Rehabilitation of the Yosemite Valley Loop Road Project

Finding of No Significant Impact
February 2006

Public Review and Comment Period	1-23
Coordination	1-24
American Indian Consultation	1-25
Conclusion	1-26
Errata Sheets	E1
Technical Corrections and Comments Requiring Changes to the Text and Graphics of the <i>Rehabilitation of the Yosemite Valley Loop Road Project Environmental Assessment</i>	E1
Changes to the Selected Alternative as a Result of Public Comment.....	E9

On page II-3, the National Park Service replaces figure II-1 – Yosemite Valley Loop Road No Action Alternative with figure II-1 (Revised) Yosemite Valley Loop Road No Action Alternative, which can be reviewed on page E5 of this document.

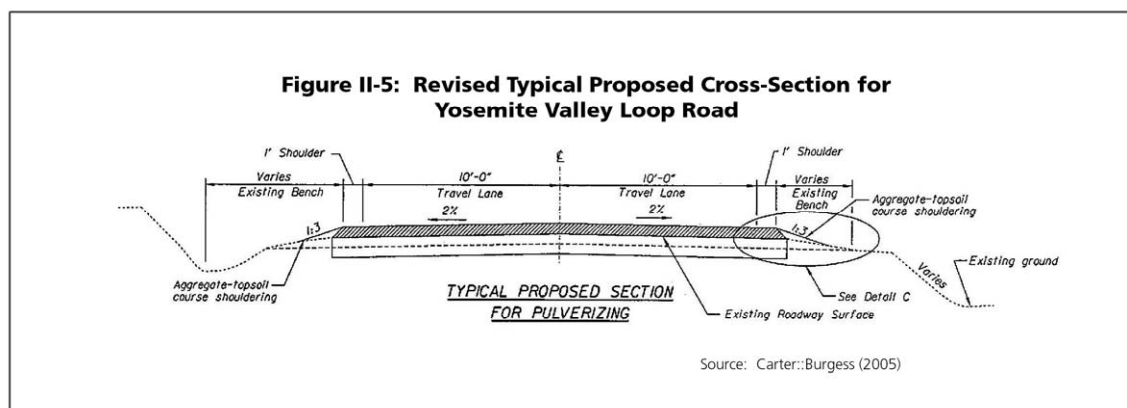
Figures II-1 and II-5 in the *Rehabilitation of the Yosemite Valley Loop Road Project Environmental Assessment* have been replaced with more accurate depictions of roadway cross-sections. Figure II-1 shows a *typical existing* cross-section of the Yosemite Valley Loop Road as well as a base map of the project area. Figure II-5 shows *proposed* cross-sections of different sections of the Yosemite Valley Loop Road. Public comment indicated that both of these figures unclearly presented information pertaining to existing and proposed road widths for the Yosemite Valley Loop Road.

In the EA, figure II-1 depicts a typical cross-section of the existing roadway but did not clearly identify the varied widths of both the existing roadway and shoulder. This figure has been revised in response to public comment to better depict the varied nature of roadway and roadway shoulders. Figure II-1 of the EA has been replaced with figure II-1 (Revised) which can be found on page E5 of the Errata Sheets for the *Rehabilitation of the Yosemite Valley Loop Road Project Environmental Assessment*.

On page II-12, the National Park Service replaces figure II-5 – Typical Proposed Road Improvement Cross-Sections with the following figure II-5 (Revised) and text.

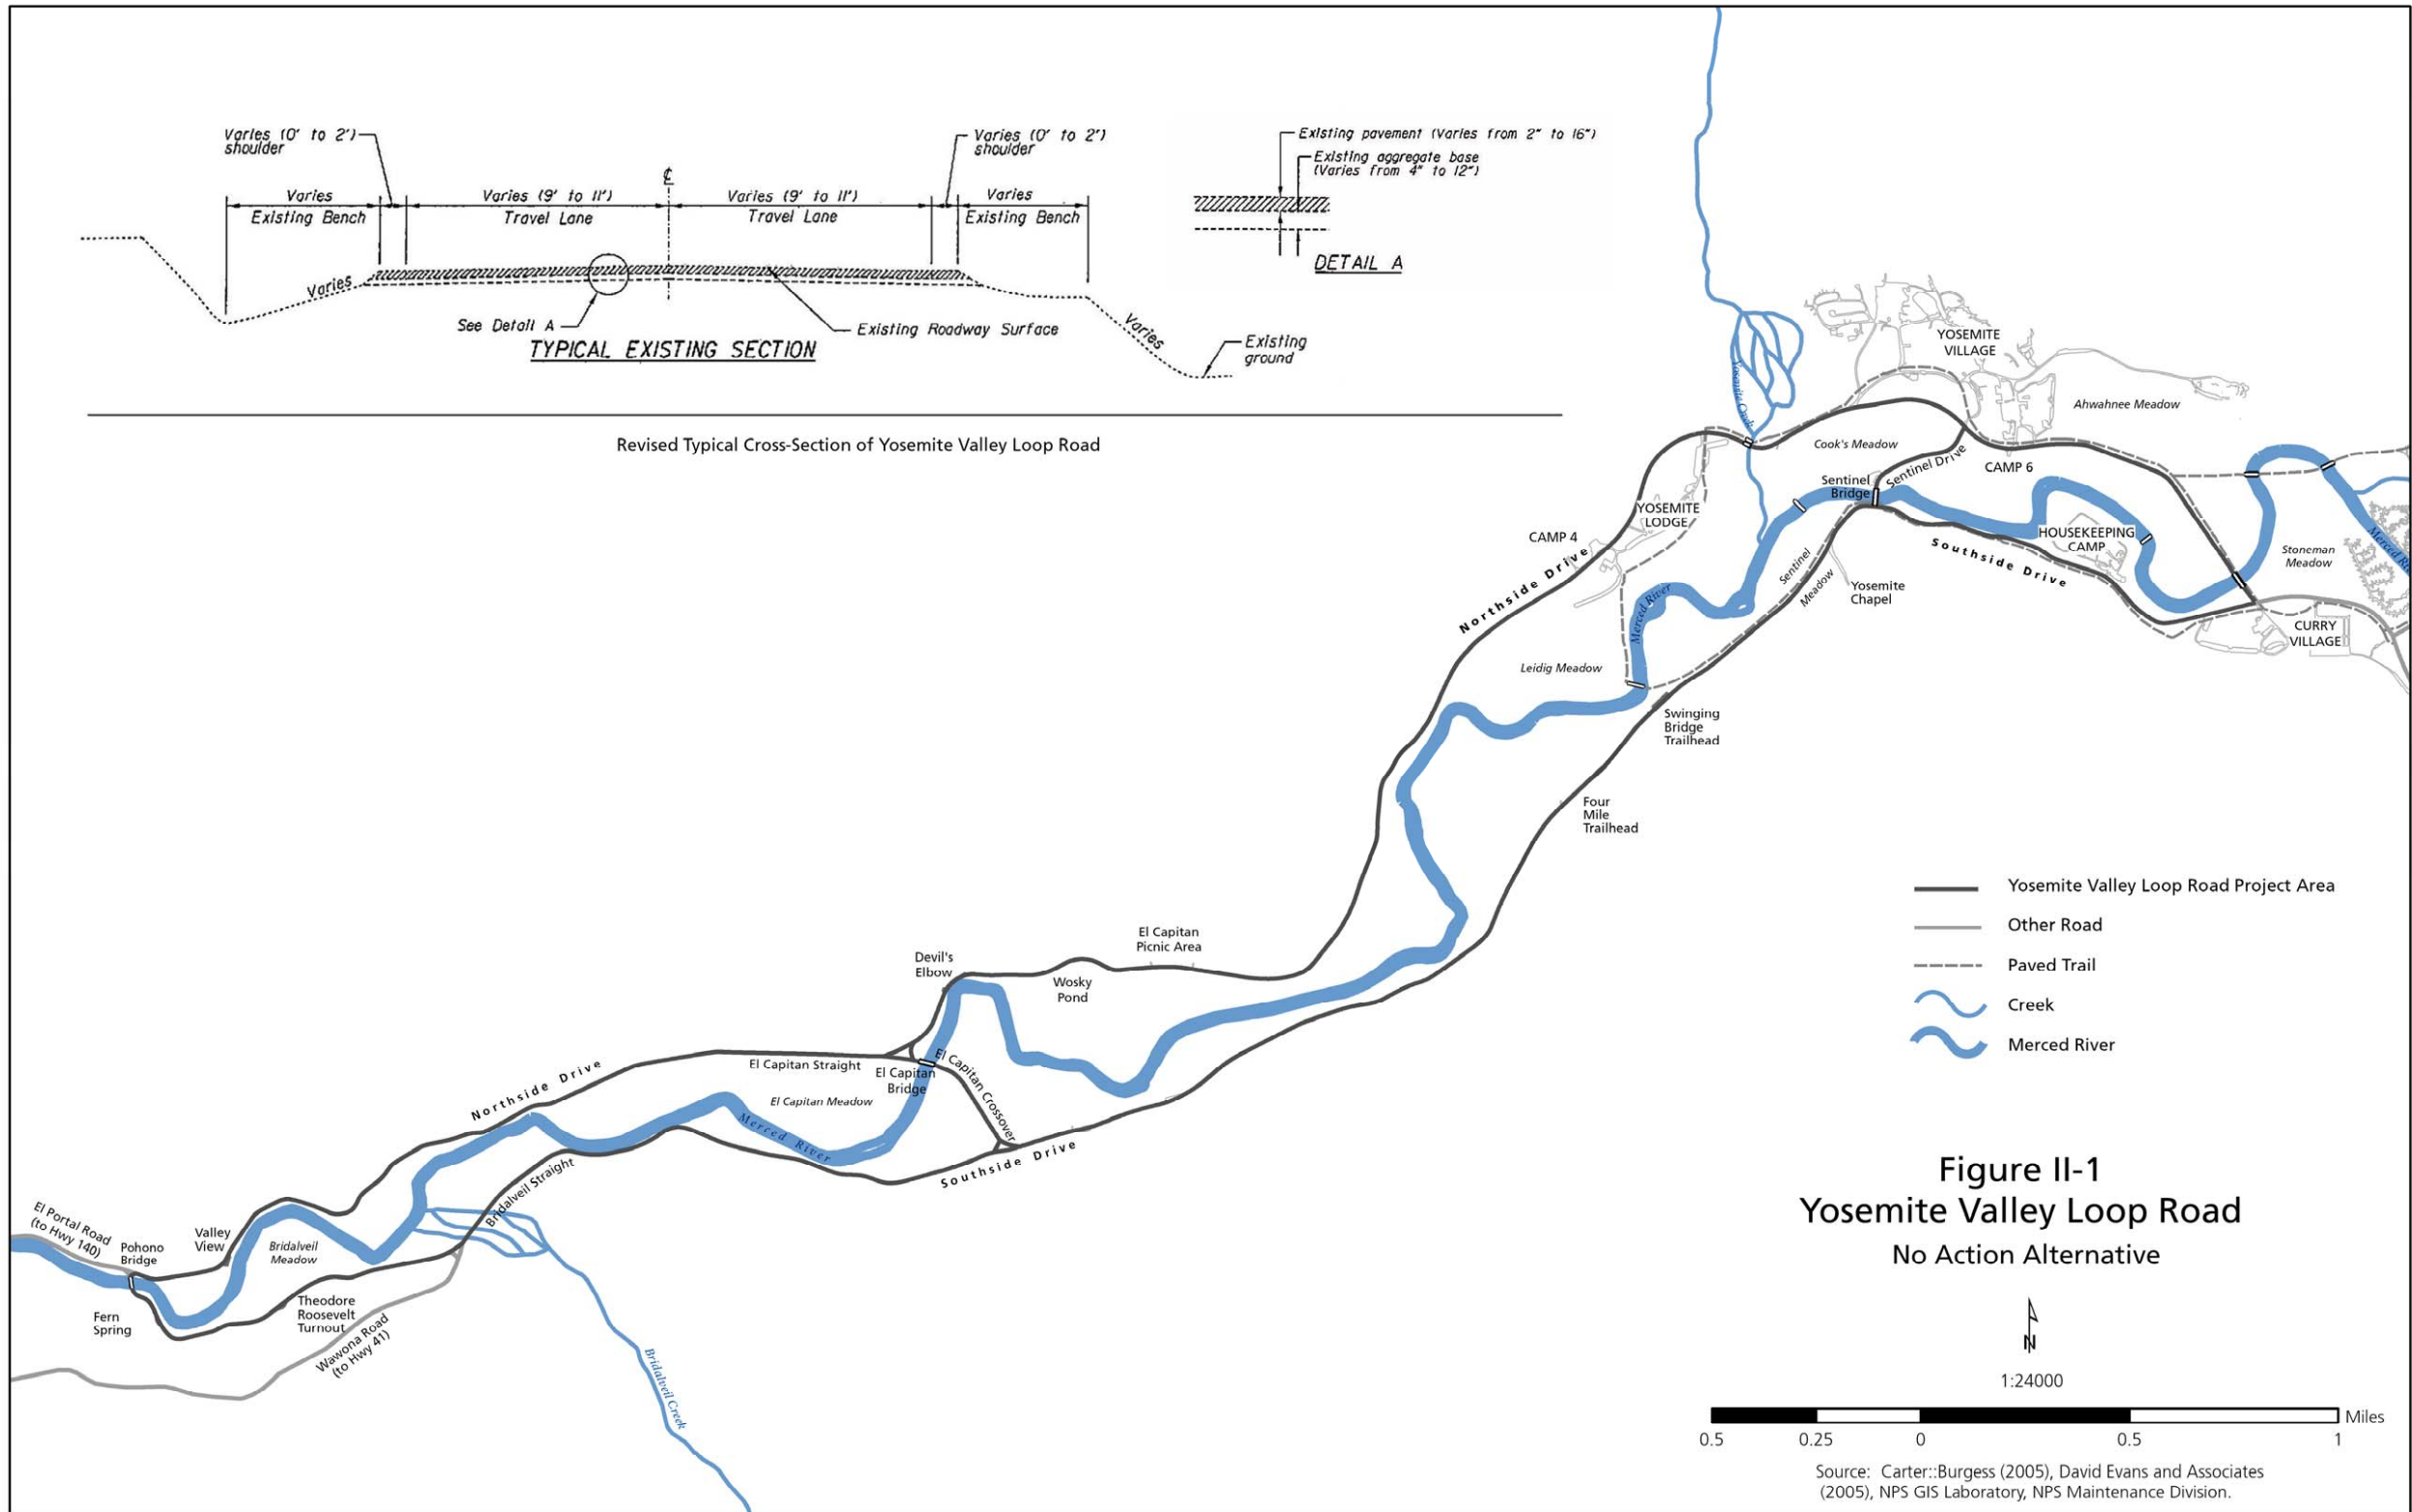
In the EA, figure II-5 depicts a proposed width of travel lanes and shoulders of the Yosemite Valley Loop Road. Figure II-5 (Revised) more clearly illustrates how travel lane and shoulder widths will be made consistent, where possible, to a standard width of 10 foot travel lanes and 1 foot shoulders. Figure II-5 (Revised) replaces figure II-5 of the EA in the Errata Sheets.

“Figure II-5 depicts proposed changes to the Yosemite Valley Loop Road. Travel lane and shoulder widths would be made consistent, where possible, to a standard width of 10 foot travel lanes and 1 foot shoulders. No trees would be removed to achieve these proposed standard travel lane and shoulder widths, nor would the existing road bench be widened to achieve these standard widths. In some locations, the existing roadway width could be made narrower.”

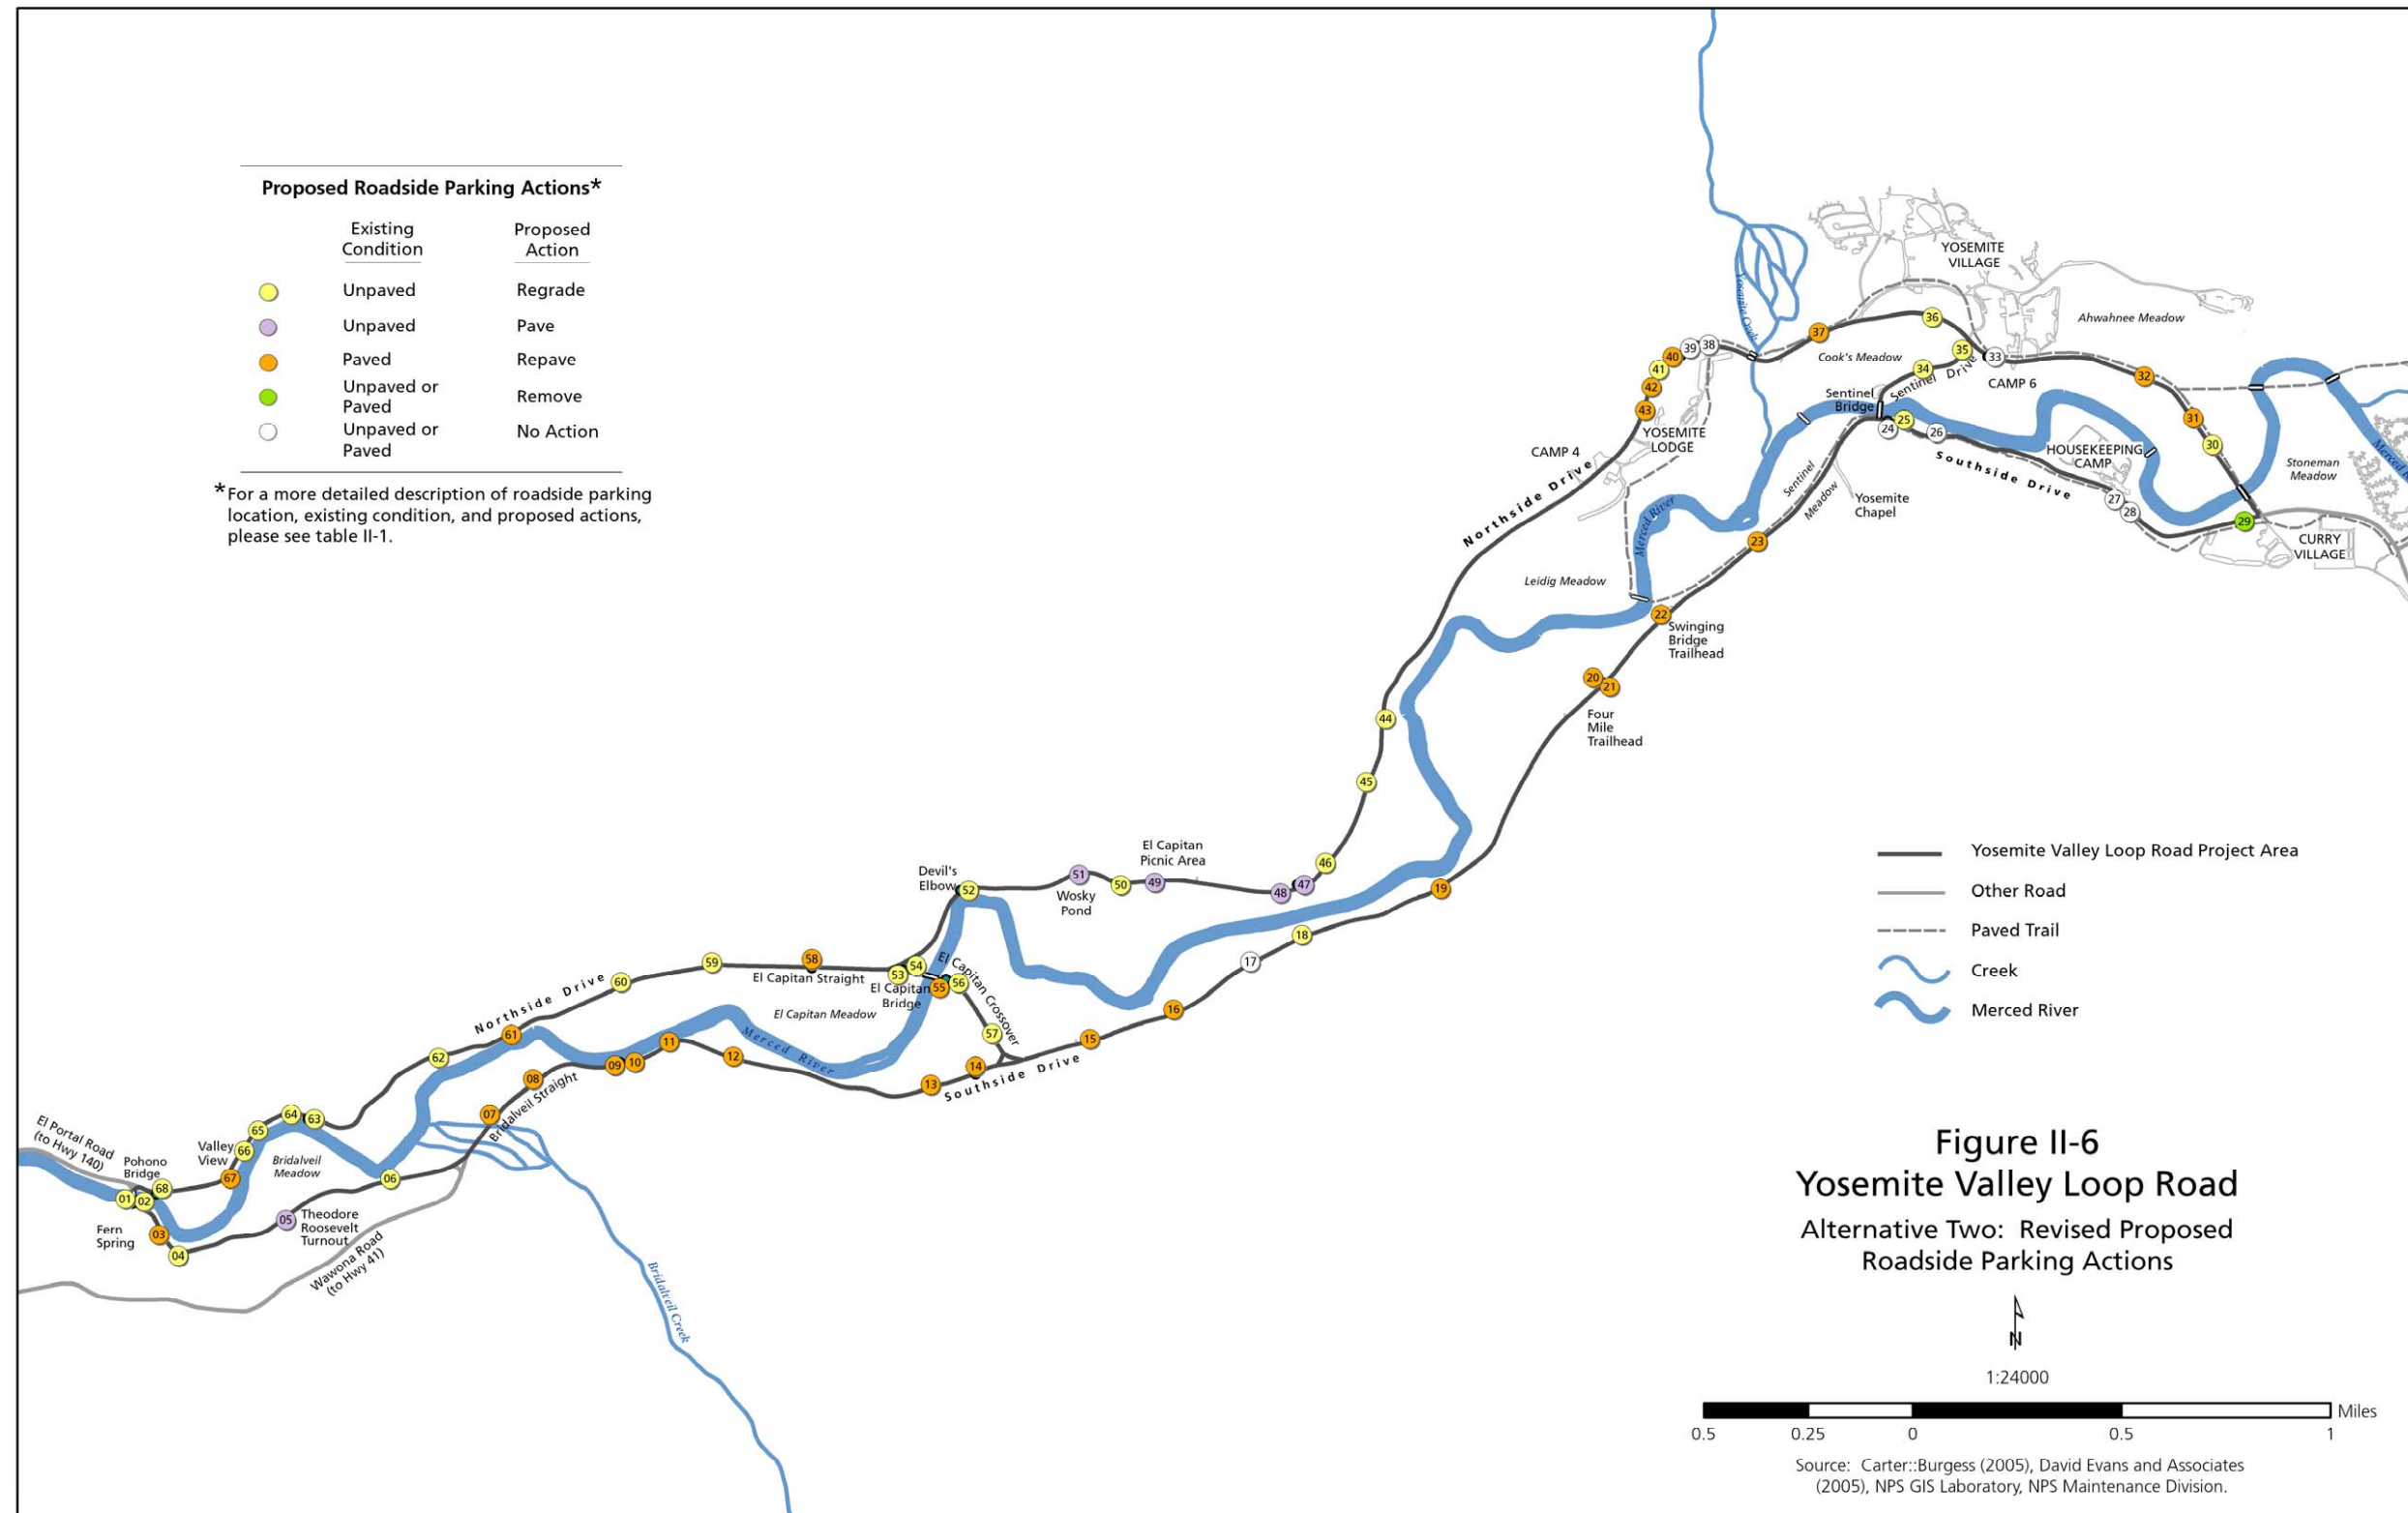
4. Table II-1 and Figure II-6 incorrectly identify existing conditions and proposed actions to road side turnouts numbered 53 and 54 near the El Capitan Bridge.

“Figure 11-6 is a brief and misleading illustration of the reductions of casual pull-over areas. Table 11-1 is more descriptive of the reductions and eliminations of casual pull-over reductions. The color coded dots on Figure 11-6 trivialize the reductions if the table is studied carefully and understood by the reader considerable reductions are expressed and implied in this table;”

On page II-13, figure II-6 - Yosemite Valley Loop Road Alternative 2: Proposed Parking Actions will be replaced with Figure II-6 (Revised) Yosemite Valley Loop Road Alternative 2: Proposed Parking Actions (page E6 of this document). Figure II-6 (Revised) reflects the changes to turnouts #53 and #54 made in table II-1.

The National Park Service has revised the proposed action to now retain four of the five turnouts originally proposed for removal under the Preferred Alternative. Turnouts #11, #64, #65, and #30, as identified in figure II-6 and table II-1, will remain and be replaced in kind. These changes are reflected in figure II-6 (Revised) which can be viewed on page E6 of this document.
